COUNCIL ASSESSMENT REPORT

Panel Reference	PPSSNH-485
DA Number	LDA2024/0066
LGA	City of Ryde
Proposed Development	Residential flat building (Building A) and associated works comprising: <ul style="list-style-type: none"> i. Torrens Title subdivision of the land into 2 lots; ii. Construction of a 24 storey residential flat building containing 231 apartments and basement parking over proposed Lot 1; iii. A Stratum subdivision to divide the basement carpark into 2 separate lots with shared circulation and shared access from the proposed Mews Road; iv. Associated Mews Road construction, landscaping, civil works, pedestrian pathways, vehicle charging, waste and loading areas, and communal open space
Street Address	Lot 102, DP 1224238 3 Halifax Street, Macquarie Park
Applicant/Owner	Landmark Group Australia Pty Ltd
Date of DA lodgement	12 April 2024
Total number of unique submissions	One (1)
Recommendation	Approval
Regionally Significant Development (Schedule 6 of the SEPP (Planning Systems) 2021)	General development over \$30 million. Cost of works: \$100,345,000 excluding GST.

Clause 4.6 requests	Precautionary 4.6 submitted for Floor Space Ratio. The report finds it unnecessary; see

Figure 2 – shadow diagrams for subject DA. Source: FJC Studio

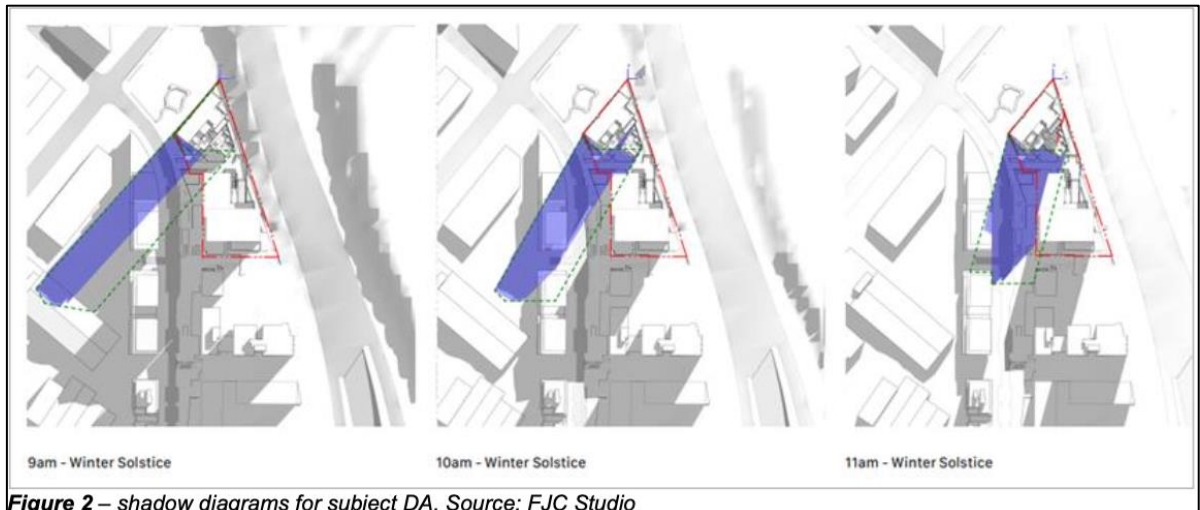
*We note the resultant overshadowing impacts onto Wicks Road South as shown above in **Figure 2**.*

We note that master planning on behalf of the landowners group is currently underway on the land immediately adjacent to the proposed development. This master planning contemplates higher density housing not dissimilar to Lachlans Line and a large ‘central park’. Doing so is consistent with the direction of the TOD precinct planning underway by State Government. It is understood that the Department’s master planning will be exhibited sometime in July to September. Accordingly, it is critical that any determination of this development application not prejudice that master planning and therefore the TOD housing initiative.

By way of specific reference to the current master planning underway on behalf of the landowners, we note that the proposed development will impact the proposed northern most building and some of the community open space (‘central park’). More generally, this again confirms the importance of no decision being made on the development application until there is greater clarity and certainty over the current Department planning.

The objector is referring to the properties located to the west of the Lachlan’s Line precinct and bounded by Wicks Road and Epping Road. This area is referred to as Wicks Road South in the Macquarie Park Innovation Precinct Place Strategy (**Figure 10**) and is identified as a future commercial core.

Shadow diagrams have been submitted by the applicant (**Figure 11**). The proposal is for a tall, slender tower. As such, the shadow is fast moving as the sun traverses the sky which ensures good levels of solar amenity. While there is some additional shadow impact to the Wicks Road South Precinct, it will only occur between 9am and 11am and will be unaffected by the proposed development during the remainder of the day. This is confirmed by the shadow assessment contained in the submission.

The development will result in a significant extent of overshadowing on the adjoining apartment site to the south during most hours of the day between 12pm and 3pm on June 21 but there will be no point during the day when this entire site will be overshadowed by the proposed development.

The additional overshadowing impact on the Wicks Road South precinct is considered to be minor and occurs only between 9am and 11am on 21 June. As a result, the objectors concerns are considered to be suitably addressed.
